REPLACE ROOF CIVIC CENTER

FRANKFORT, KENTUCKY

"AS-BUILT" NOTE: 25 July 2005

REPLACE ROOF -- CIVIC CENTER FRANKFORT, KENTUCKY		DRAWING NO. A-1
AS BUILT DATE 25 JULY 2005	ROOF PLAN	
DRAWN BY <i>MARTIN</i>	COMMONWEALTH OF KENTUCKY FINANCE AND ADMINISTRATION CABINET DEPARTMENT FOR FACILITIES MANAGEMENT DIVISION OF ENGINEERING FRANKFORT, KENTUCKY	
CHECKED BY <i>MARTIN</i>	WILLIAM C. MARTIN, P.S.C. ARCHITECTS-ENGINEERS 620 EUCLID AVENUE LEXINGTON, KENTUCKY	
A & B FILE 573-75	REVISED BY DATE 18 Nov. 2003	
AGENCY AUTHORIZED AGENT	APPROVED FOR PROGRAM CONCEPT ONLY DATE	
DIVISION OF ENGINEERING	APPROVED FOR PROGRAM CONCEPT ONLY DATE

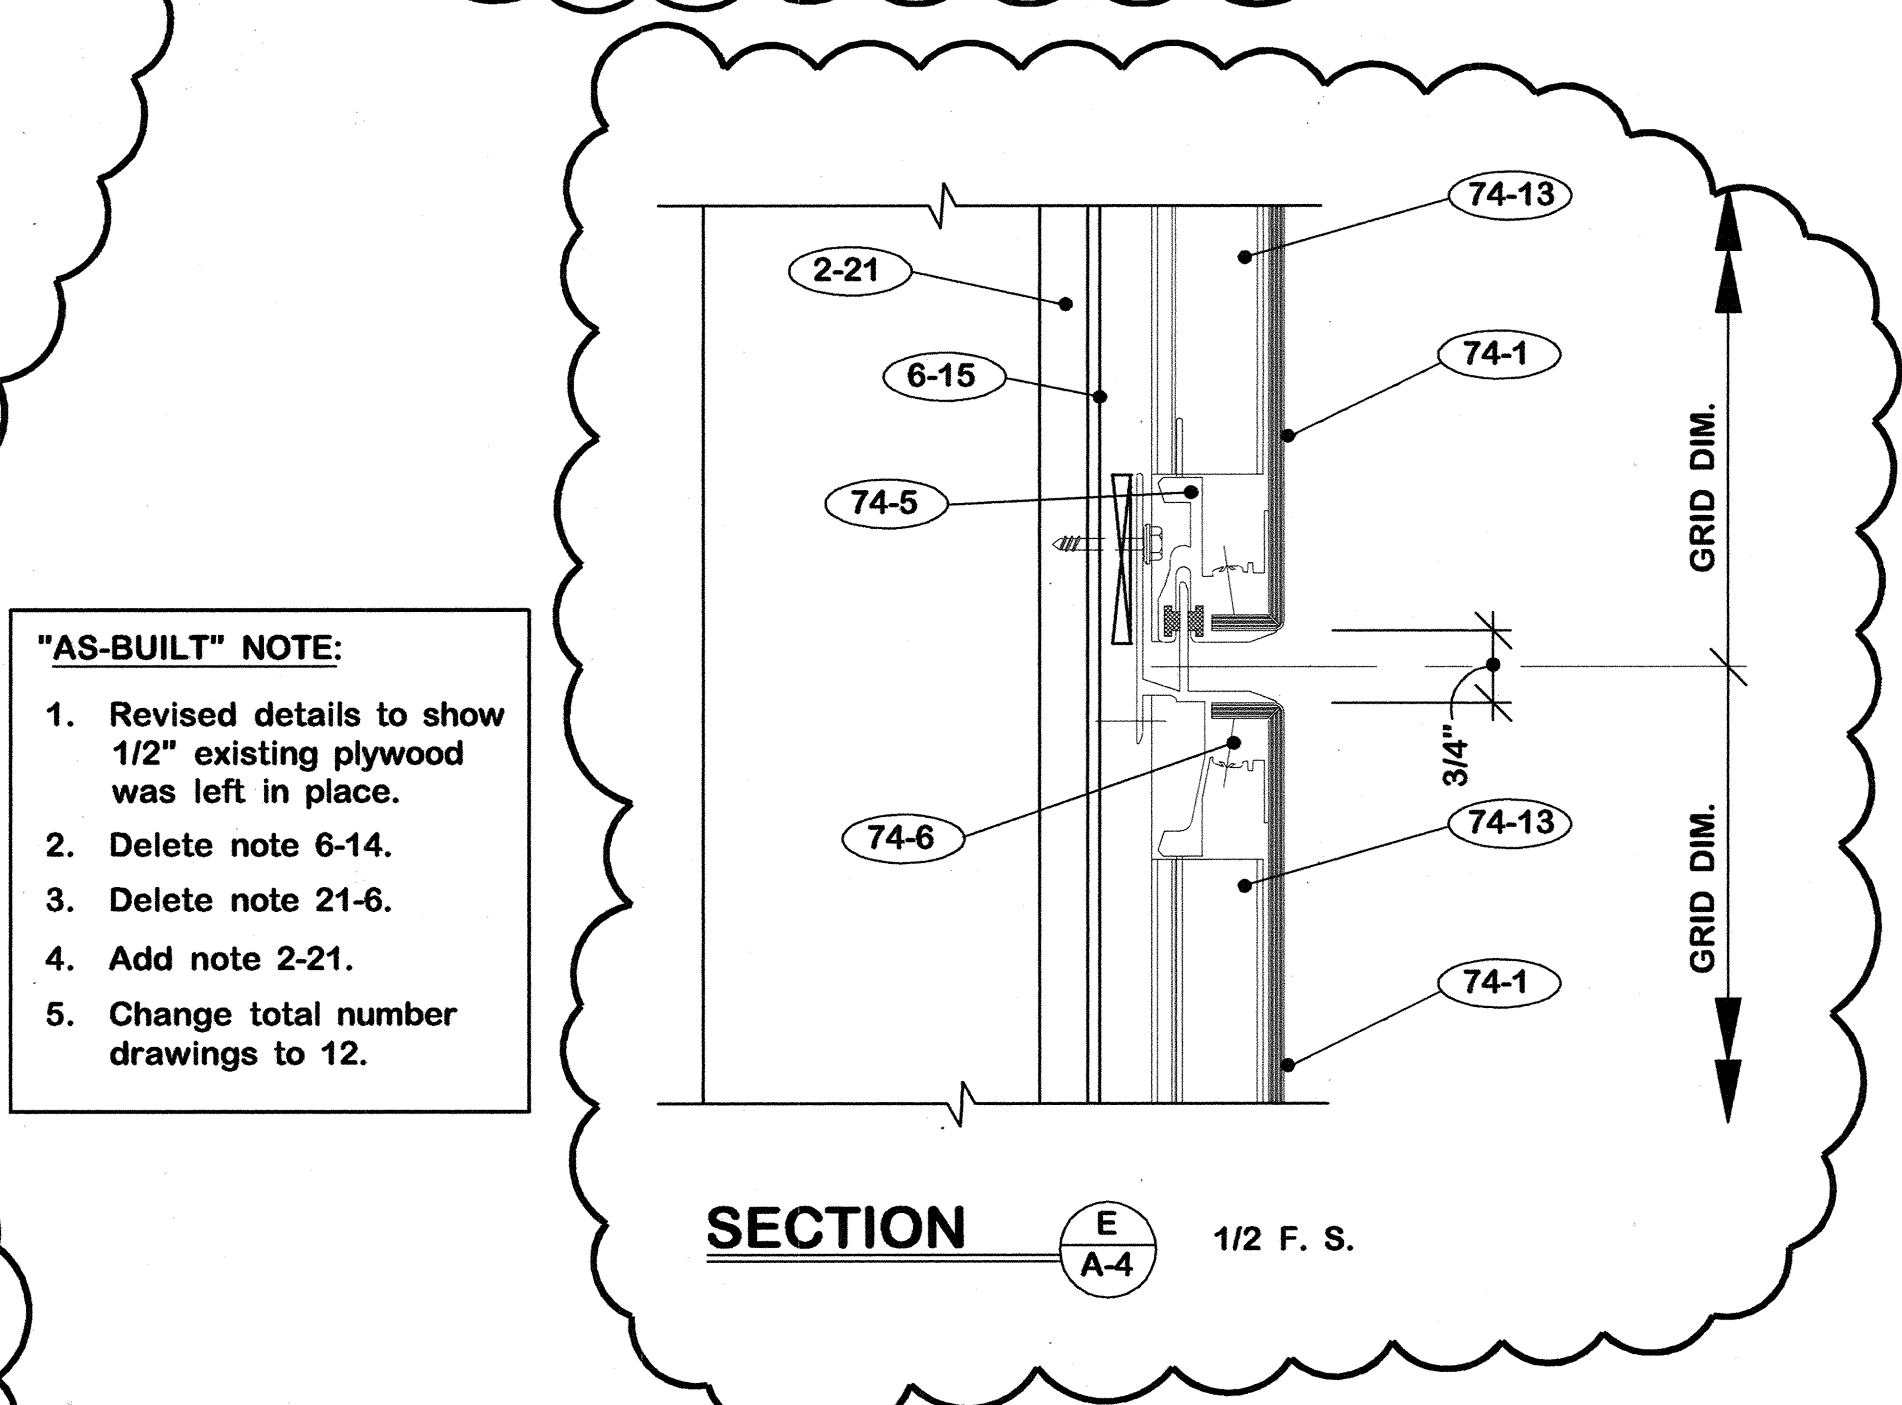
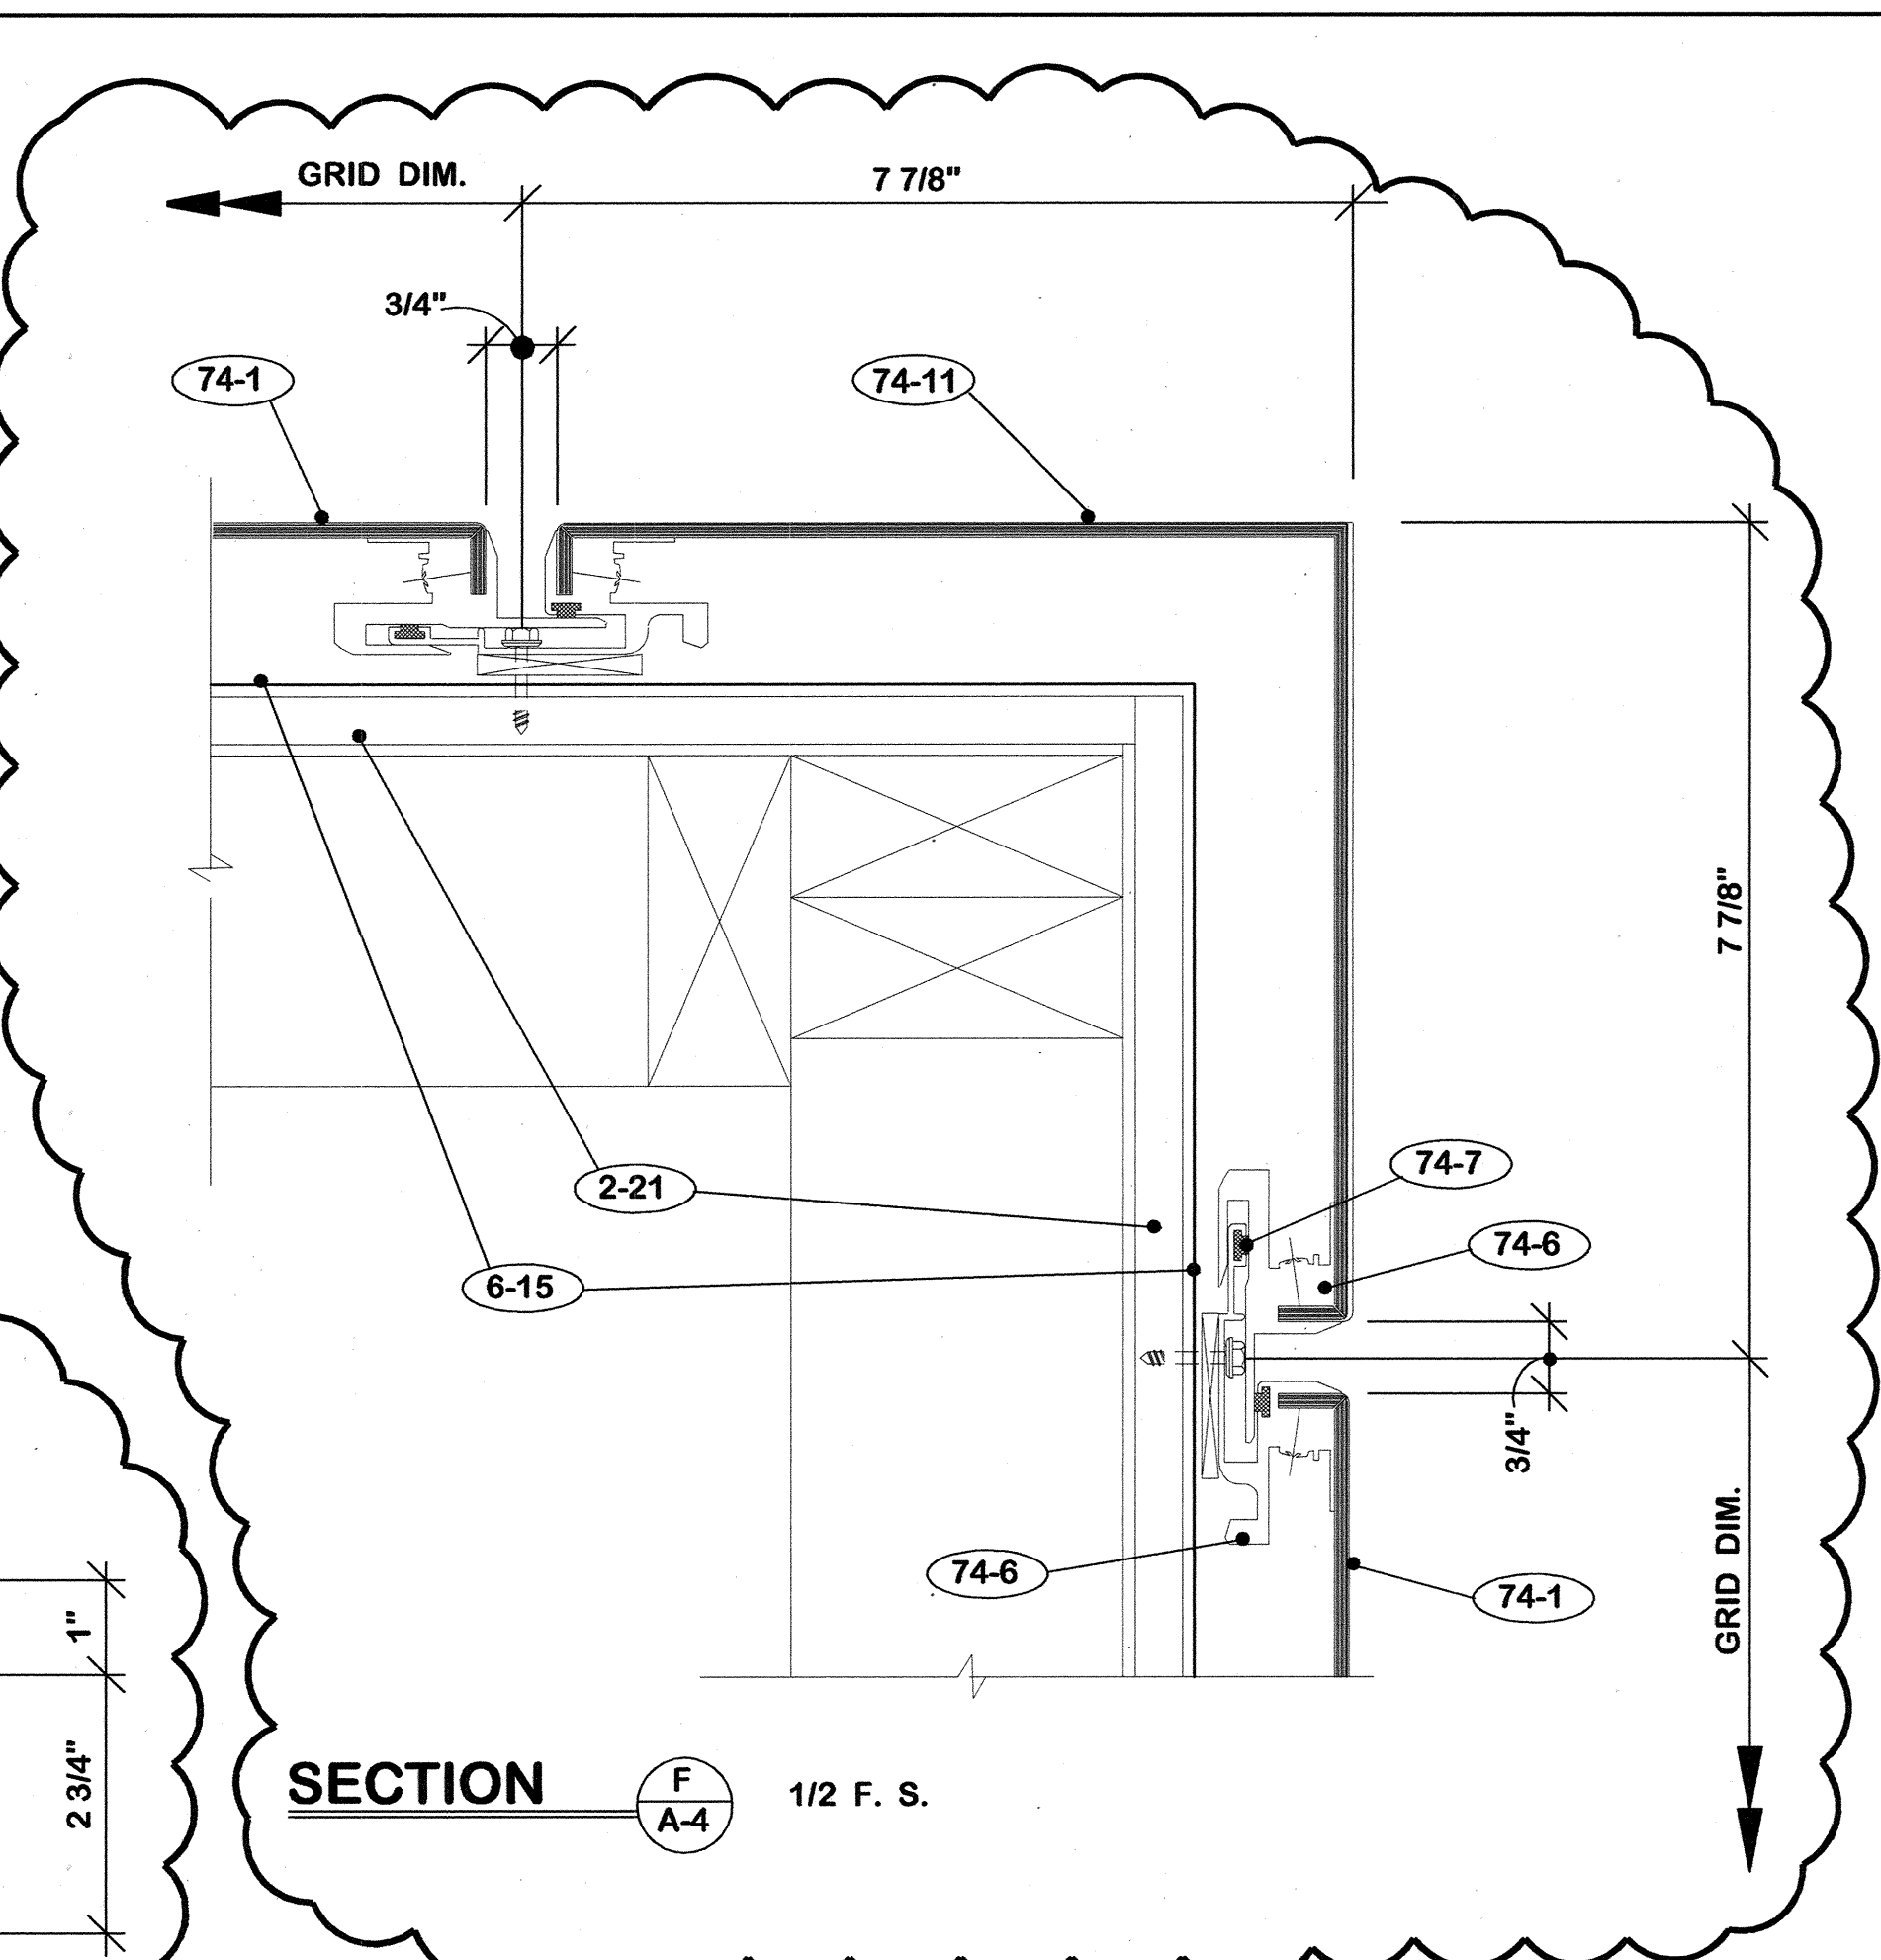
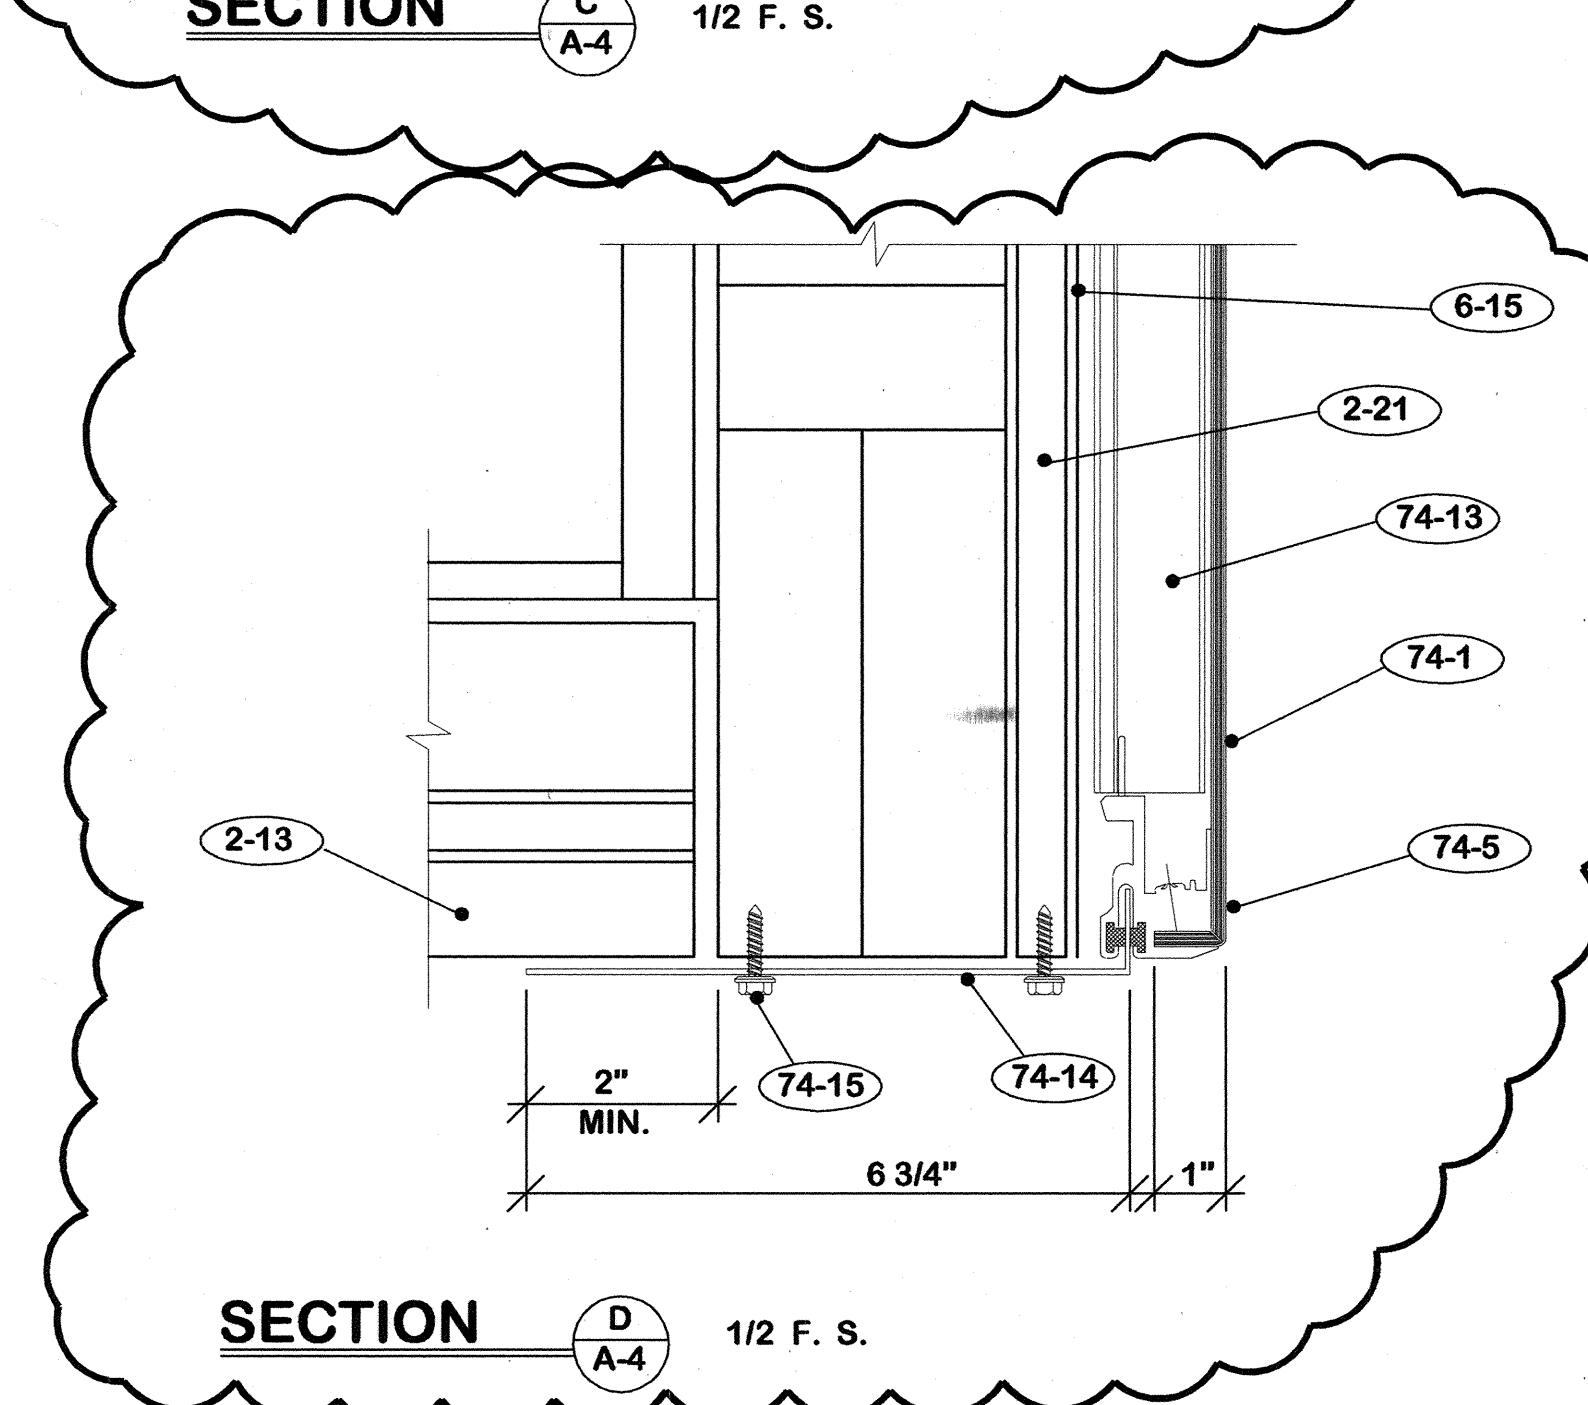
"AS-BUILT" NOTE:

1. Revised details to show 1/2" existing plywood was left in place.
2. Delete note 6-14.
3. Delete note 21-6.
4. Add note 2-21.
5. Change total number drawings to 12.
